October 2020  
Central Valley Ag Group Bulk Whole Cottonseed Transload Facility

# Final Initial Study/Mitigated Negative Declaration for the Central Valley Ag Group Bulk Whole Cottonseed Transload Facility at the Port of Stockton

# 1 Final Initial Study/Mitigated Negative Declaration

## Western Regional Climate Center Data 1992-2002

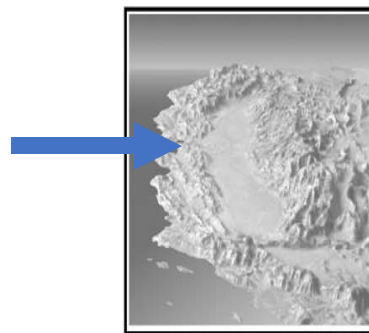
Data that conflicts with the description of prevailing winds has been obtained from two sources: Western Regional Climate Center<sup>6</sup> and the California Air Resources Board (CARB) air quality monitoring station located at Public Health Services on Hazelton Avenue in Stockton CA. The data from Western Regional Climate Center includes prevailing wind direction based on the hourly data from 1992-2002 obtained from the Stockton Municipal Airport (KSCK) and is defined as the direction with the highest percent of frequency.

The Sierra Club Delta-Sierra Group commented on discussions related to prevailing winds. As noted in Section 3.3.3.1.1 of the Draft IS/MND, the discussion of wind direction is specific to the regional setting and is correct as described. As no dispersion modeling was warranted, wind direction was not considered in the analysis completed for the impact determination. Therefore, no changes to the information presented in the Draft IS/MND are required.
